1964 - 1966 Corvette: Service Bulletin: Reverse Lockout Mechanism Revised

Subject: Reverse Lockout Mechanism Revised
Model and Year: 1966 Corvette (4-Speed Transmission)
Source: Chevrolet Technical Service Bulletin
Bulletin No: TSB #66-10
Section: VIIb
Date: November 29, 1965

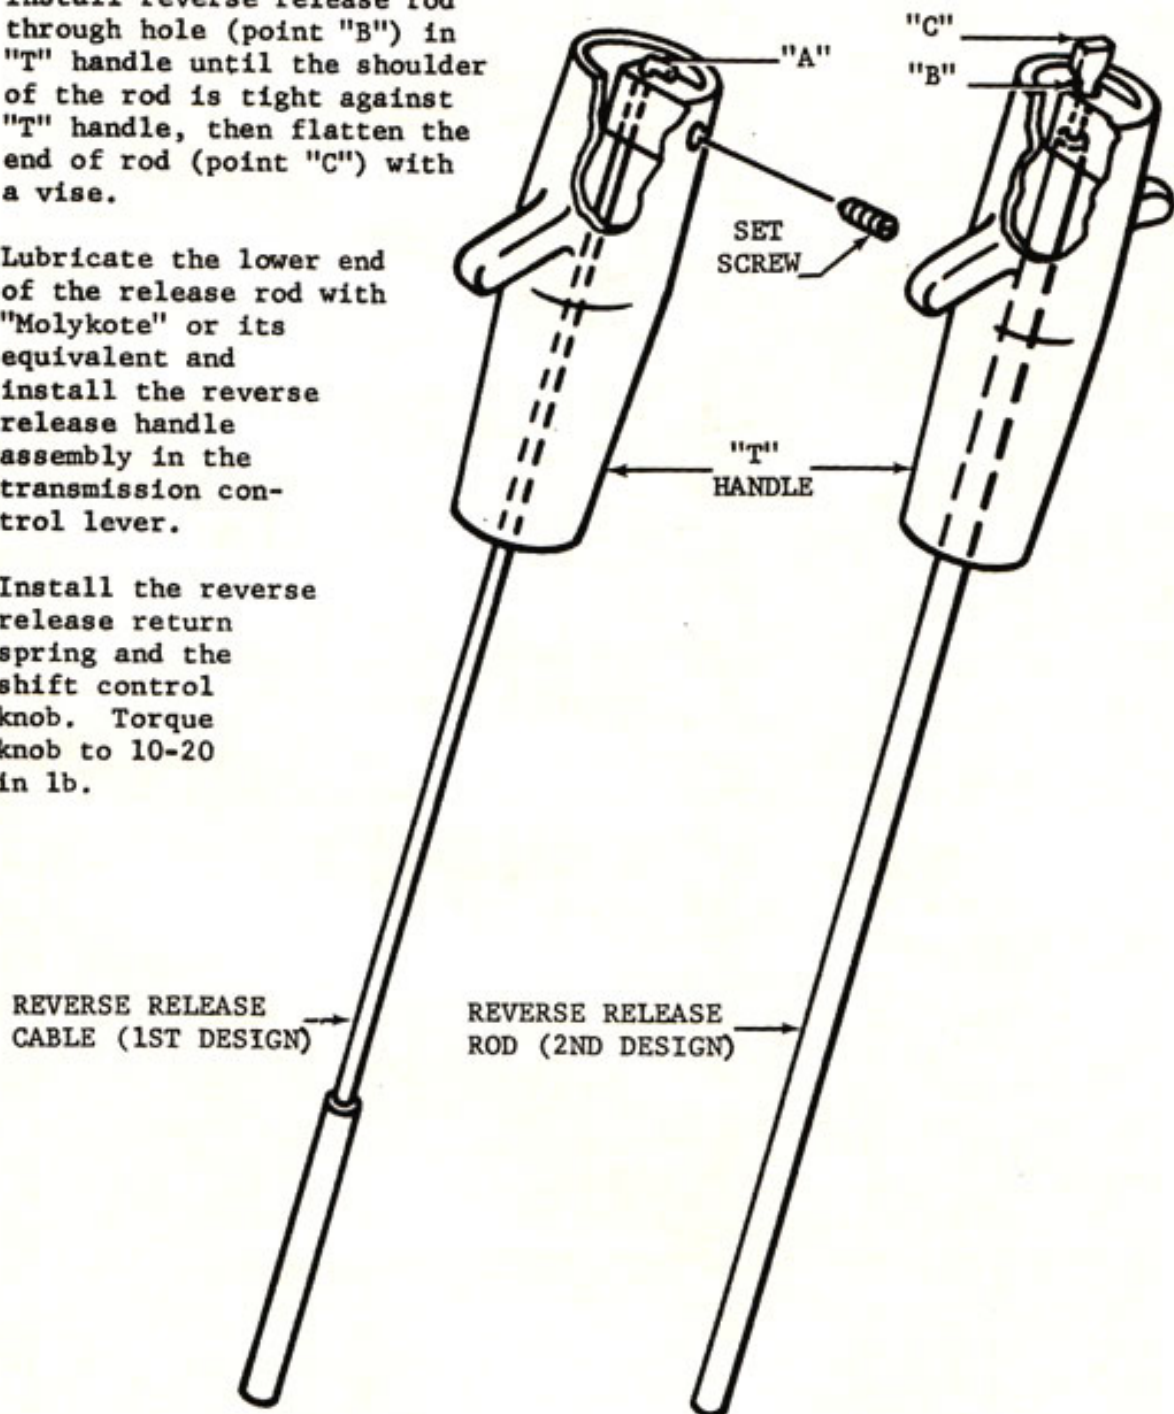
The reverse lockout mechanism for the Corvette 4-speed transmission was revised interim 1966 production. In the early design mechanism, the reverse release cable position is normally controlled by a set screw in the "T" handle. However, should the set screw loosen, this design doesn't insure cable movement with handle movement. Should the cable remain in the up position, accidental selection of reverse gear would be possible.

To eliminate this possibility, the reverse release cable has been replaced by a reverse release rod. The lower diameter of the reverse release rod is larger than the hole in the "T" handle. This larger diameter forms a shoulder and when the "T" handle is released, the rod is forced downward. This design eliminated the set screw and insures the reverse release rod will be lowered whenever the "T" handle is down.

The reverse release rod, Part No. 3889461, may be used in place of the reverse release cable on 1964-65 and early 1966 Corvettes. Instructions for installing the reverse release rod are outlined on page2.

1. Remove the reverse release handle assembly by first removing the shift control knob and the reverse release handle return spring.
2. Straighten the release cable (point "A"), then remove and discard the set screw and reverse release cable.
3. If necessary, enlarge the release cable hole (point "B") in "T" handle to .089"/.093".
4. Install reverse release rod through hole (point "B") in "T" handle until the shoulder of the rod is tight against "T" handle, then flatten the end of rod (point "C") with a vise.
5. Lubricate the lower end of the release rod with "Molykote" or its equivalent and install the reverse release handle assembly in the transmission control lever.
6. Install the reverse release return spring and the shift control knob. Torque knob to 10-20 in lb.
